Planning Commission

Special Called Meeting Agenda

December 15, 2025 | 6:30 PM
Frances Meaders Council Chambers
151 Willowbend Road

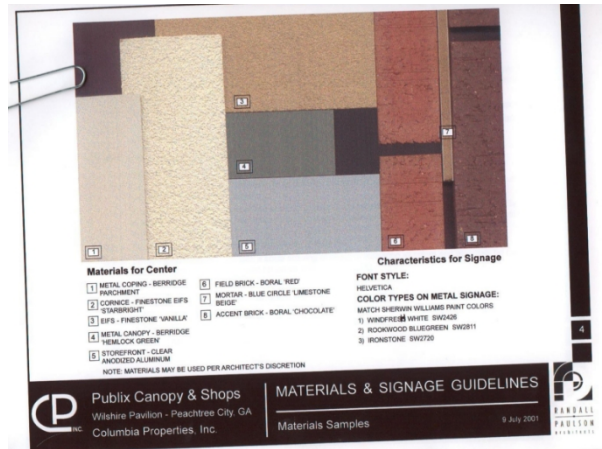
Chick-fil-A is seeking approval for the following color changes:
(no building materials have changed)

- Field paint - Sherwin Williams **Westhighland White, SW7566**
- Accent paint - no accent, all stucco is SW7566
- Trim paint - remains the same, SW6089

Staff feels the new paint color for the Chick-fil-A located at 1222 HWY 74 S is similar to the cream color in the Wilshire Pavilion color palette. The new paint color is also a neutral color and similar to other cream colors approved in the recent past for three other properties located in the Wilshire Pavilion design guideline area. Approval is at the discretion of the Planning Commission.

SHEET
EXTERIOR ELEVATIONS

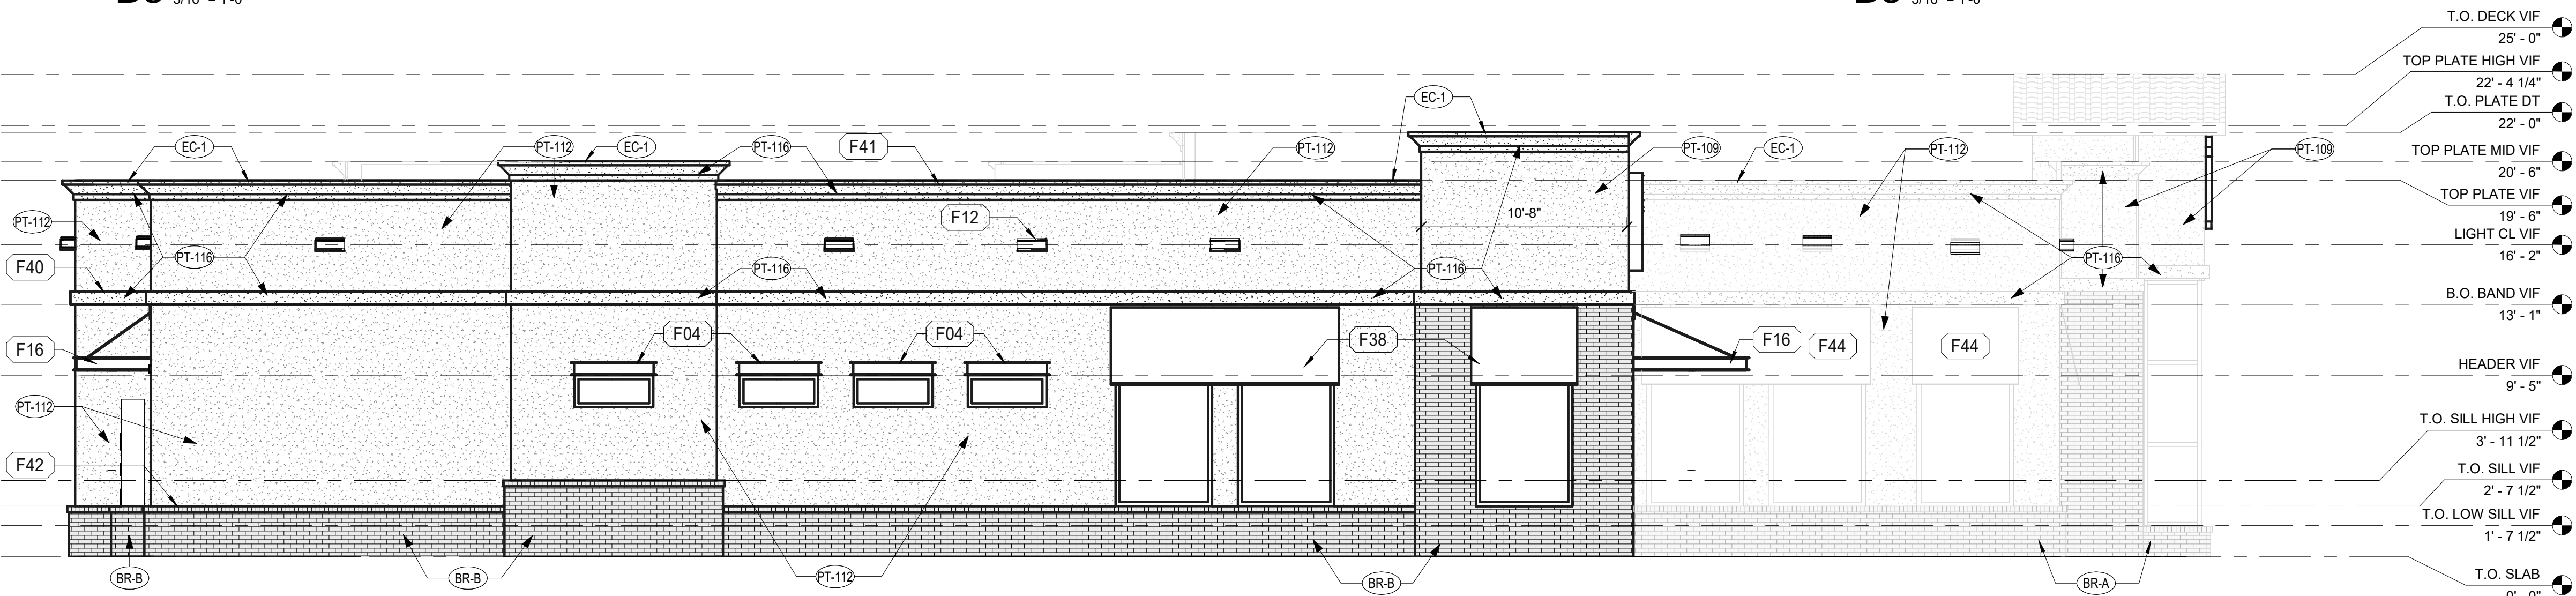
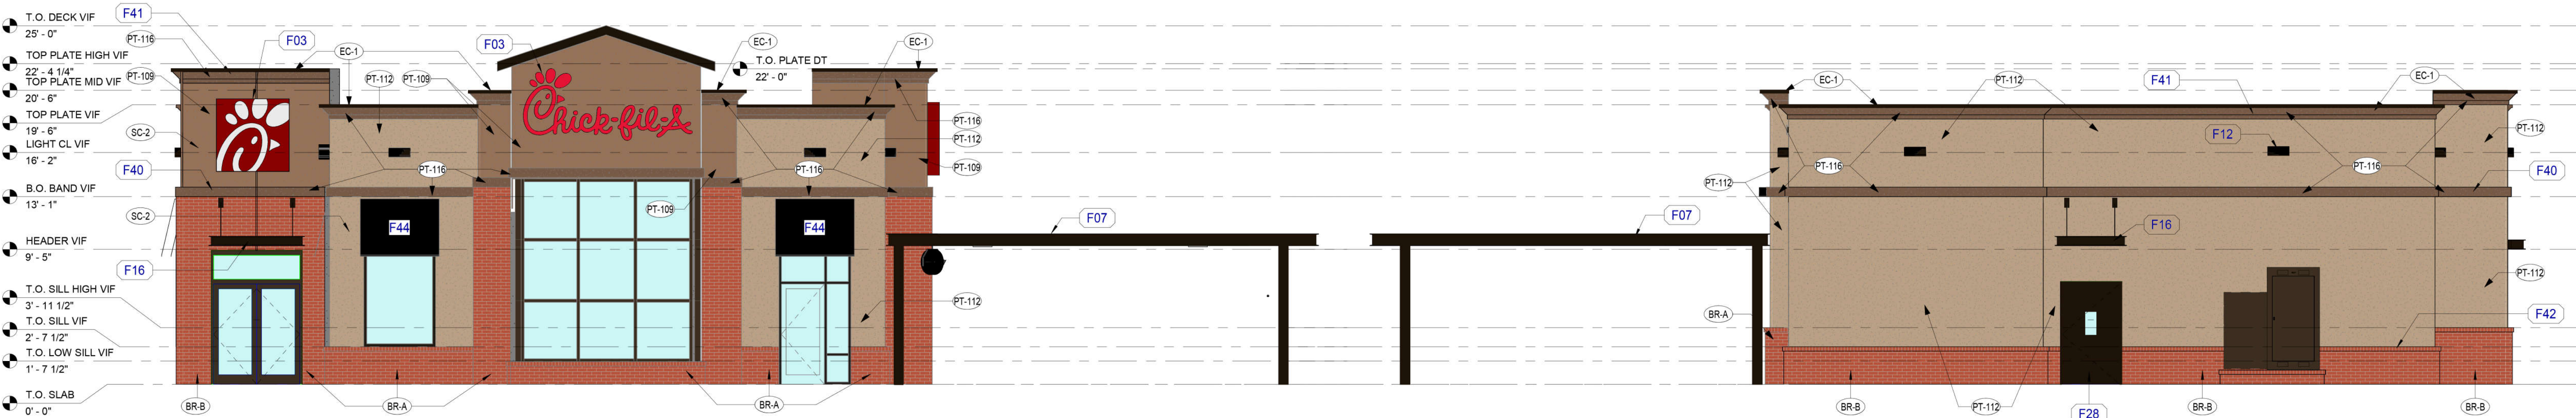
PT-112: Westhighland White
SW7566
